**Addendum No. 1**  
**January 13, 2023**

Project: Baltic High School Addition  
Baltic, South Dakots  
Arch Project No. 2957

Architect: Architecture Incorporated

**8.36**

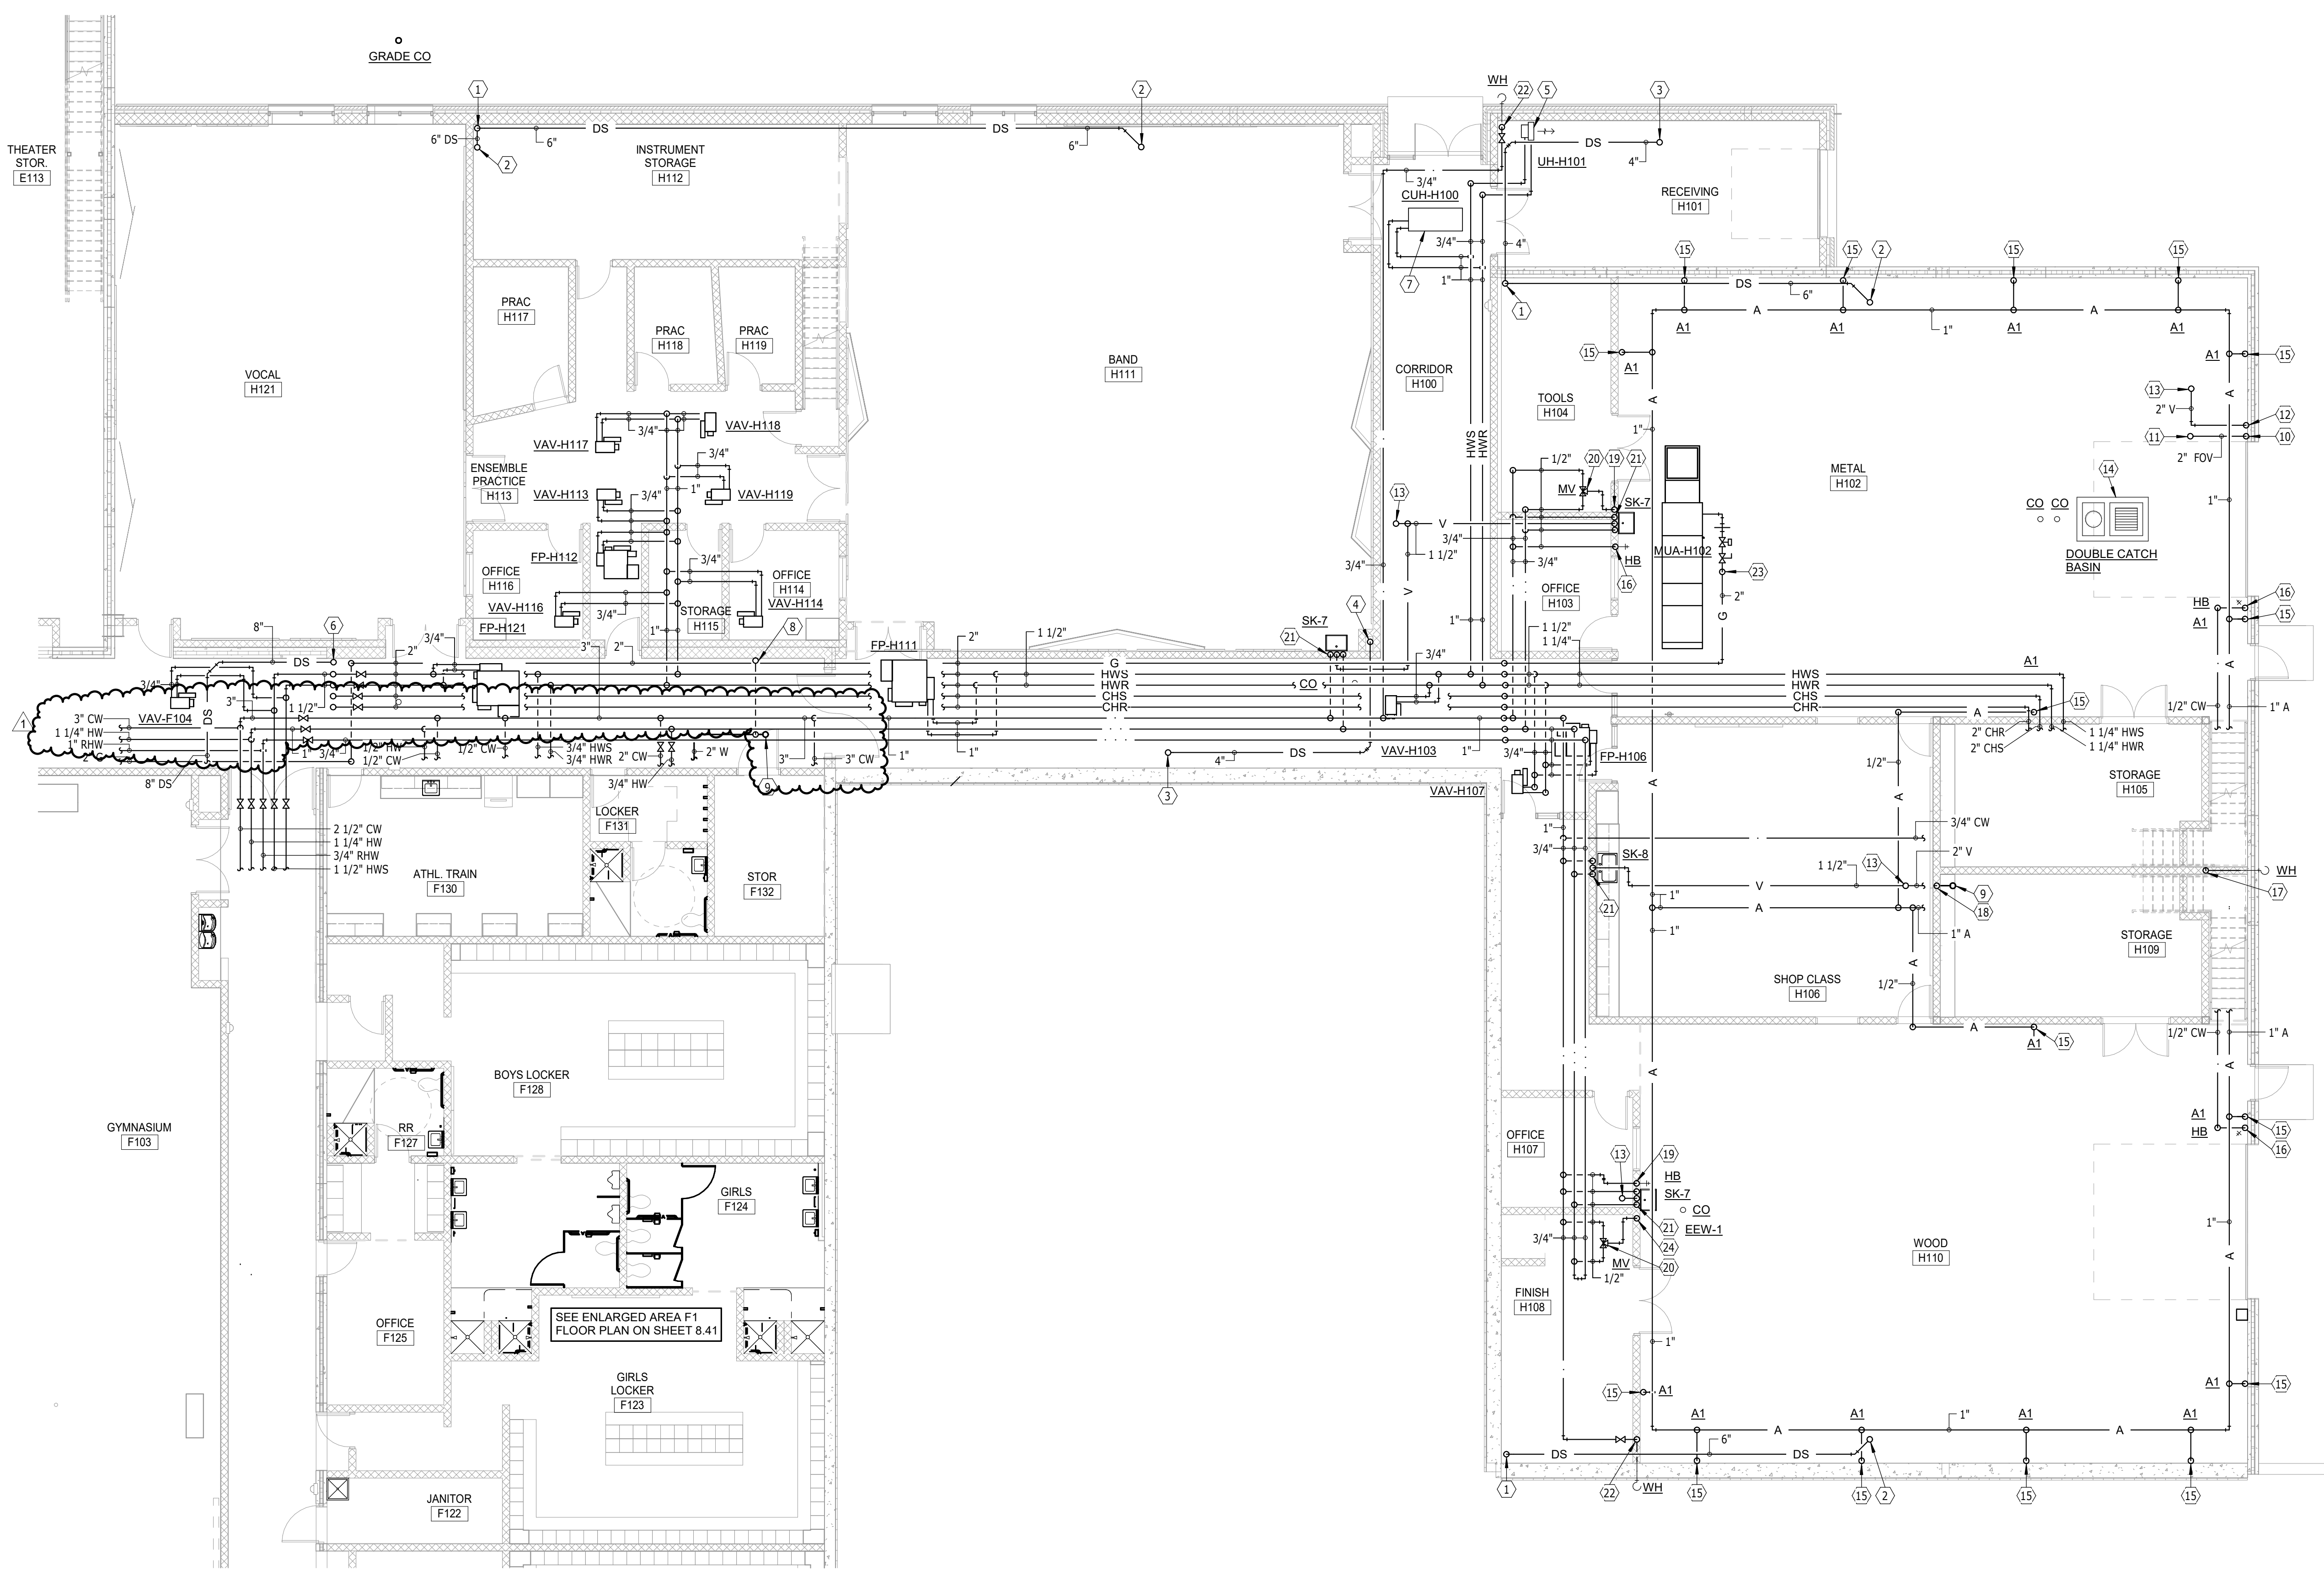
7) DRAWING SHEET 8.36 – FIRST FLOOR PLAN – AREA F – PLUMBING & HEATING AND ENLARGED FIRST FLOOR PLAN – LIFE SKILLS AREA F – PLUMBING & HEATING

- a) Modify CW piping size as shown. Refer to revised Drawing Sheet 8.36, Addendum 1, dated 1/13/23.
- b) Add 4” CW service. Refer to revised Drawing Sheet 8.36, Addendum 1, dated 1-13-23.

8.38

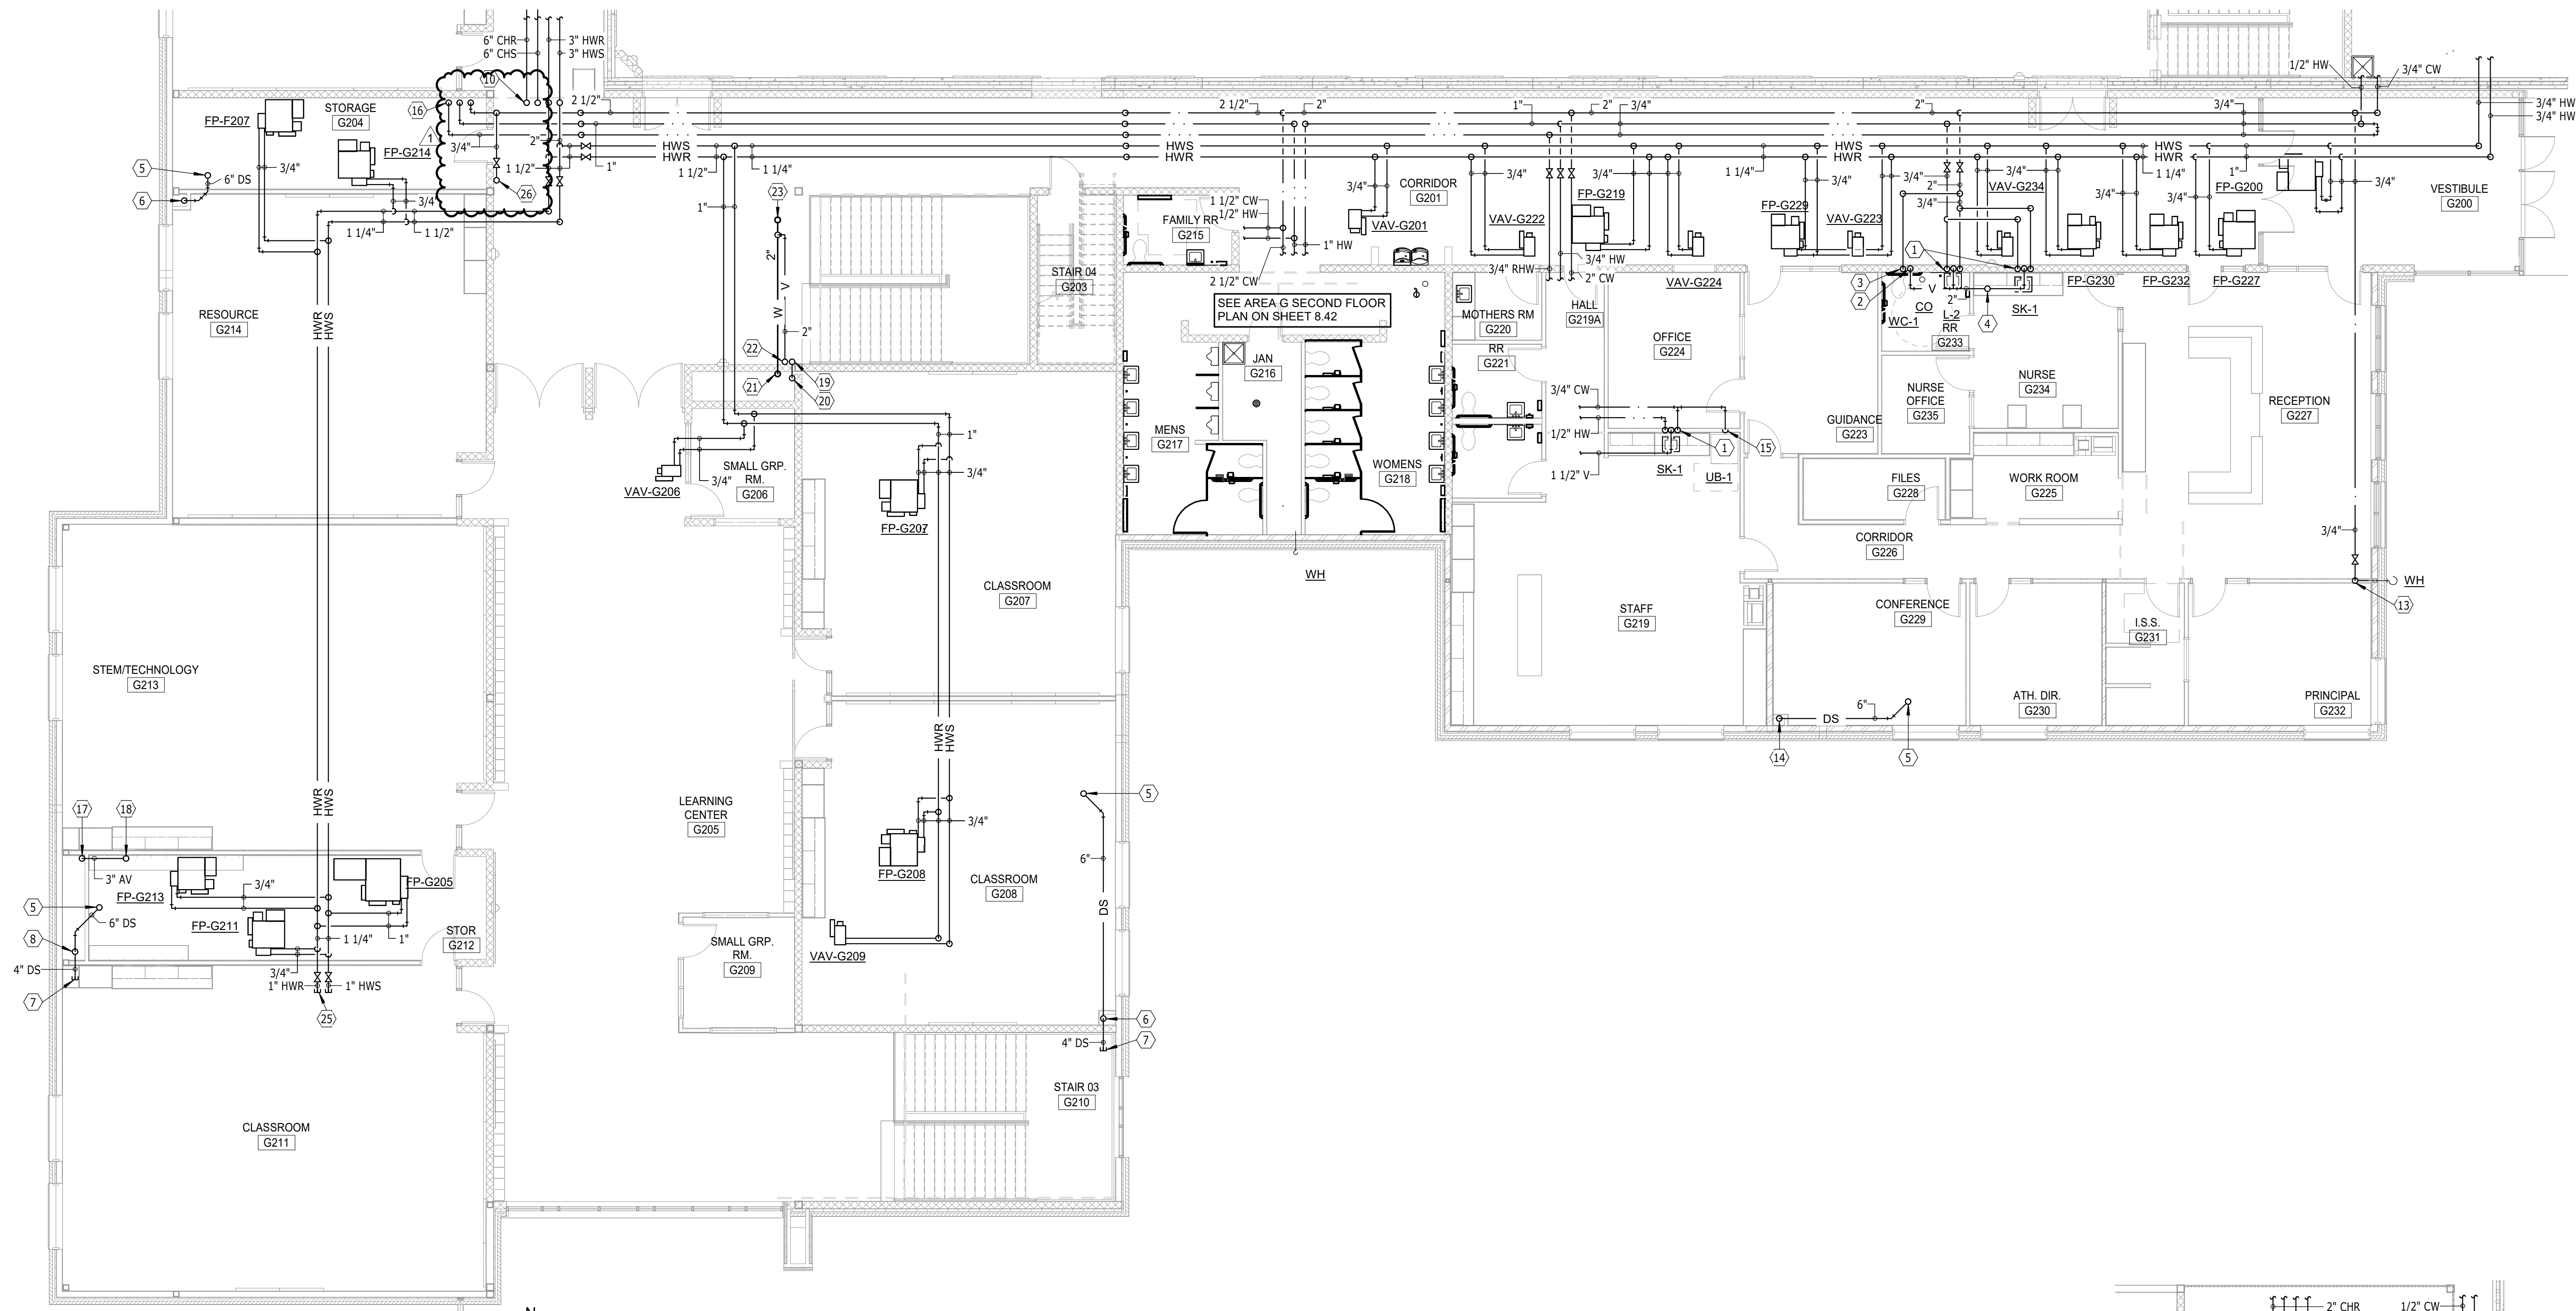
- 8) DRAWING SHEET 8.38 – FIRST FLOOR PLAN – AREA H – PLUMBING & HEATING
  - a) Modify CW piping size as shown. Refer to revised Drawing Sheet 8.38, Addendum 1, dated 1/13/23.
- 9) DRAWING SHEET 8.40 – SECOND FLOOR PLAN – AREA G – PLUMBING & HEATING
  - a) Add ¾” CW piping & hose bibb to Penthouse. Refer to revised Drawing Sheet 8.40, Addendum 1, dated 1/13/23.
- 10) DRAWING SHEET 8.42 – ENLARGED SECOND FLOOR PLAN – AREA F – PLUMBING & HEATING
  - a) Add 3” water meter & associated piping. Refer to drawing sheet 8.42, Addendum 1, dated 1/13/23.
  - b) Revised Plumbing Note 36 to add expansion tank size. Refer to drawing sheet 8.42, Addendum 1, dated 1/13/23.
- 11) DRAWING SHEET 8.42 – ENLARGED PENTHOUSE PLAN – AREA G – PLUMBING & HEATING
  - a) Add ¾” CW piping & hose bibb to Penthouse. Refer to drawing sheet 8.42, Addendum 1, dated 1/13/23.
